AFFIDAVIT

Response to PG&E Report 411-77.55

Subject: Failure Analysis of Cracked Field Weld No. 212, Diablo Canyon Unit 1, Steam Generator 1-2, Nozzle-To-Pipe Weld.

SECTION THRU PIPE NEAR F.W. 197

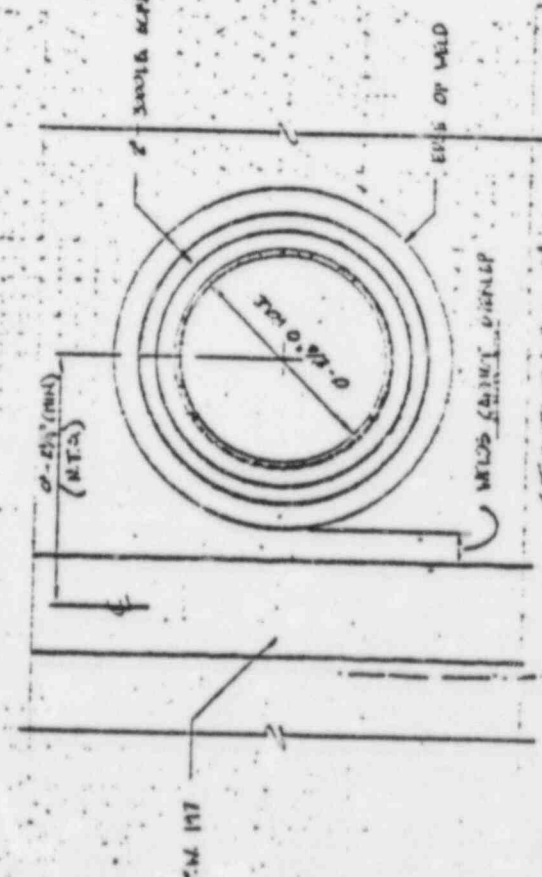
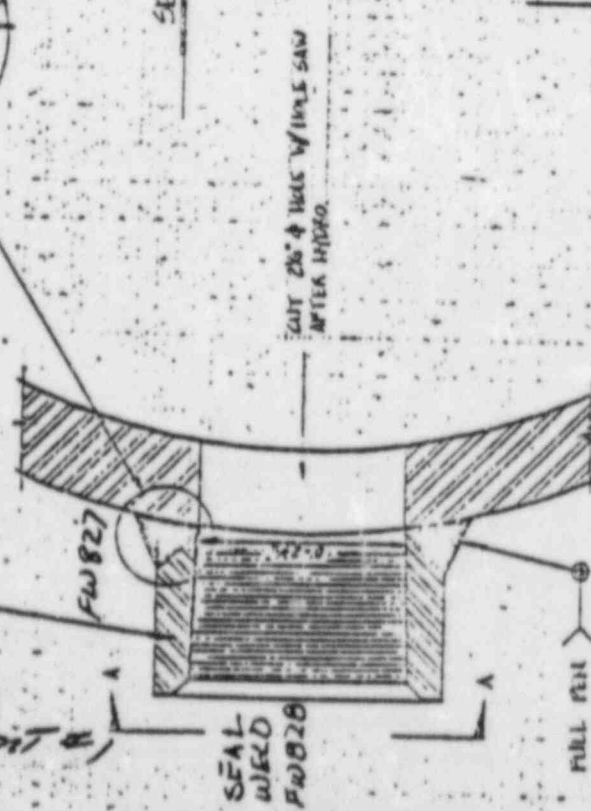
Explanation of Discrepancy: Radiography series revealed "drop through" with questionable indications. This was found after the radiograph and weld had been final accepted. For further details, see attached Pullman Kellogg U.R. No. 3370.

- PROCEDURE:
1. FIELD ON 2" - 3000 LB. SCREWED COUPLING
  2. WELD COUPLING
  3. CUT THRU PIPE WALL W/ 2 1/2" WIDE SAW
  4. GRIND OUT 10. OF F.W. 197

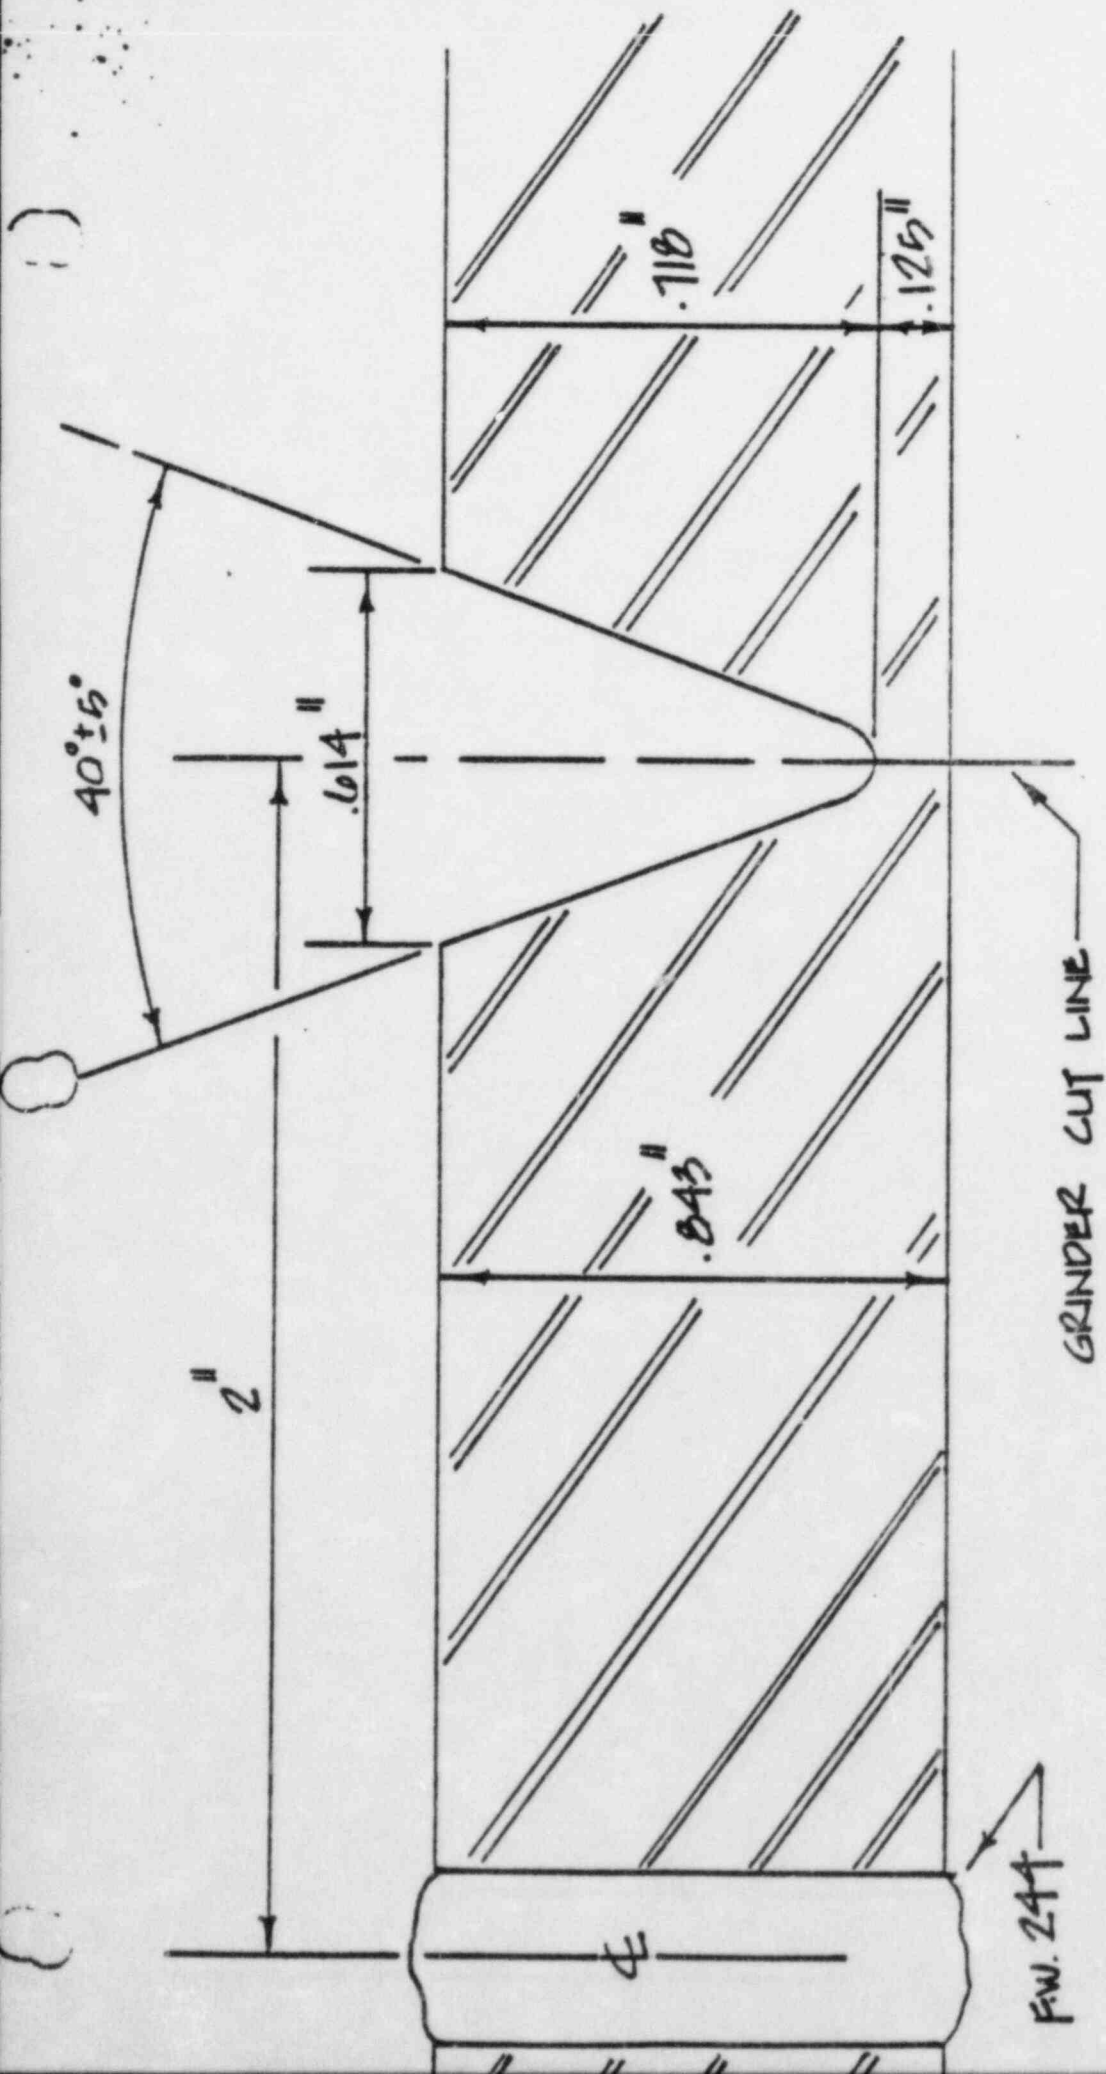
Add the following to Step #5 and delete original Steps #7, 8, 9 and 10. Perform the following repair:

- Grind the bevels to facilitate Fit-Up of F.W. 549.
- M.T. I.D. of F.W. 244 using ESD-247 coil method, and clean grooved root pass at F.W. 244 per ESD-215.
- Remove the dam from the nozzle at F.W. 244.
- Preheat F.W. 244 to a minimum of 250°F; interpass not to exceed 550°F maximum. Maintain this preheat until stress relief begins.
- Weld to procedure 200 (F.W. 244 R1), using E70S2 wire with the GTAW process, to conform to blended configuration of the balance of the weld. I.D. ONLY
- Grind and polish the added weld metal to blend with base metal surfaces.
- Inspect and NDE to ESD-215 and PG&E DER TO PERFORM L.P. AT PREHEAT-TEMP.  
FURNISH MWK WITH COPY OF P&E CERT.

- Stress relieve at F.W. 244 R1 and F.W. 549 1100°F to 1150°F per ESD-218.
- NDE F.W. 244 R1 and F.W. 549 to ESD-207.
- " " " " to ESD-211 PG&E 9/30/77
- Add information to process sheets.

Findings at F.W. 244

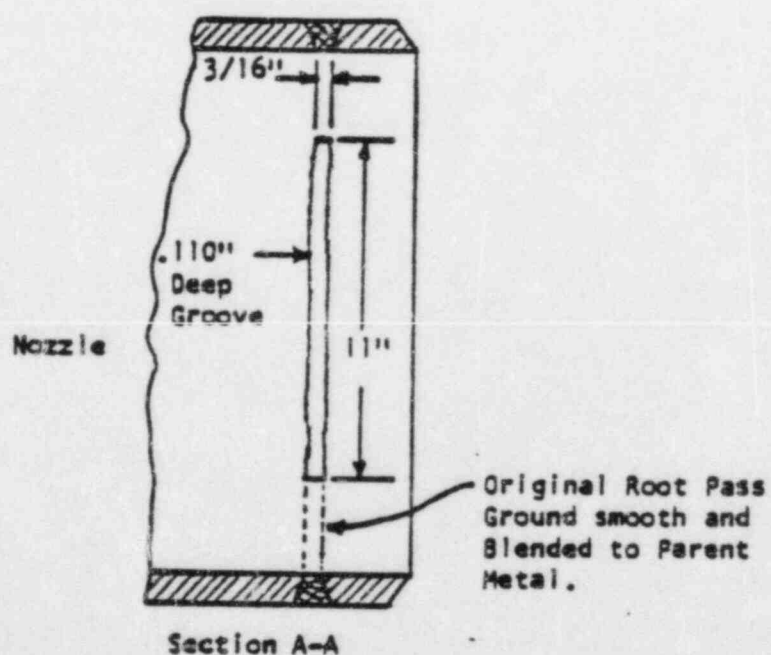
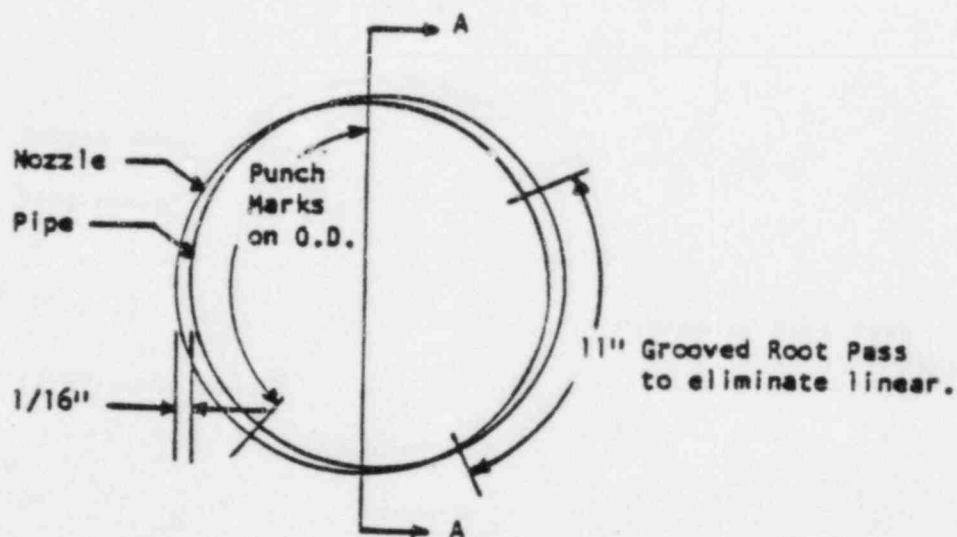
NOTE: Average Wall Thickness = .580" to .600"  
Remaining Wall At Groove = .450"  
Punch Marks On The O.D. = .047" Deep  
(Punch Marks are directly on the fusion line of F.W. 244 to 1/8" inside the fusion line .047" deep.)

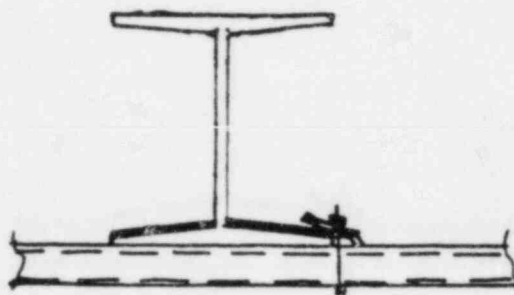
Correct. Notice Line contact at toe and heel of plate. When bolt is torqued properly, clamp should not be easily displaced.

Incorrect. Line contact but not at toe. When torqued, this tends to slip off the steel marker.
